7C Defense Against Common-Mode Failure in Safety-Related, Software-Based I&C Systems

The information in this appendix of the reference ABWR DCD, including all subsections and figures, is incorporated by reference with the following departures.

STD DEP T1 3.4-1 (Figure 7C-1)

Figure 7C-1 Implementation of Additional Diversity in SSLC to Mitigate Effects of Common-Mode Failures

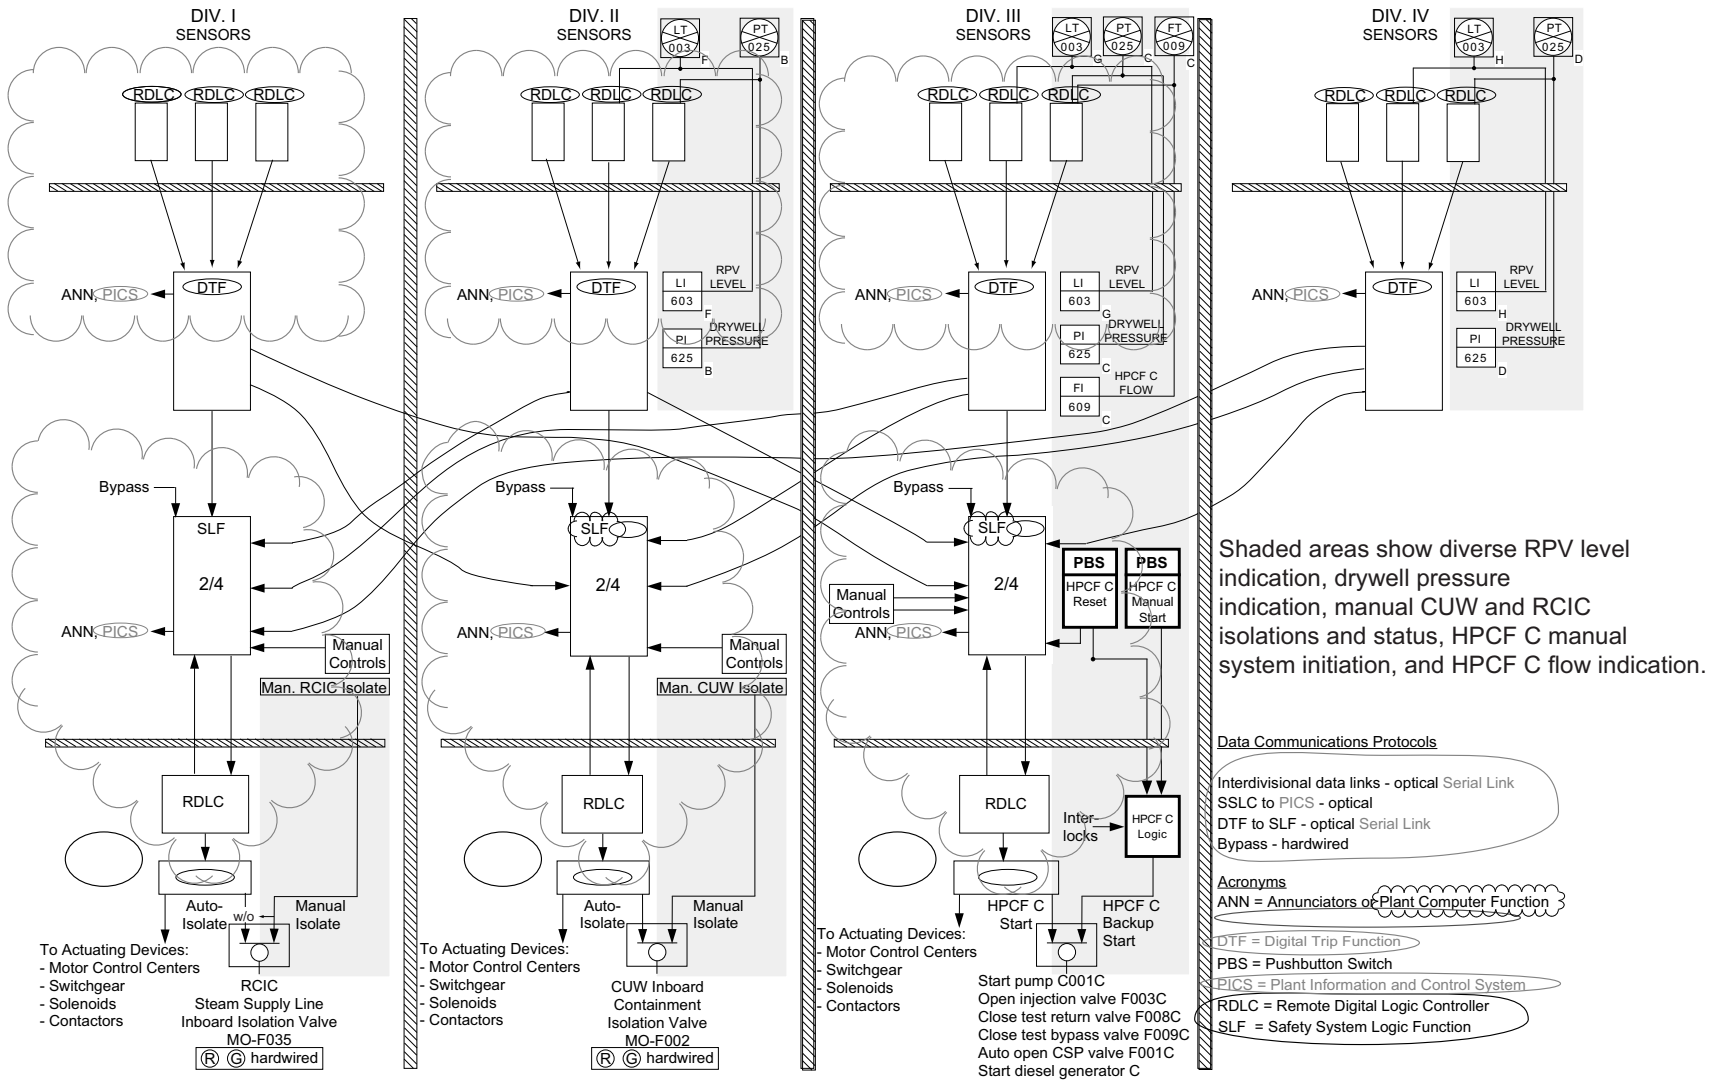
- (2) Defense-in-depth configuration:
 - (a) Fail-safe RPS and fail-as-is ESF in separate processing channels
 - (b) Control systems are independent of RPS and ESF in separate ~~triplicated processing network~~ communication functions using diverse hardware and software from the ~~Essential Multiplexing System~~ Essential Communication Function (ECF) network
- (3) Equipment diversity
 - (d) HPCF manual start in loop C (Division III) is implemented in equipment that is diverse from the automatic start function. All interconnections are hardwired and control and interlock logic is provided in the form of either

- (v) Remote shutdown system (~~analog~~ diverse, hardwired) provides shutdown cooling functions and continuous local display of monitored process parameters.
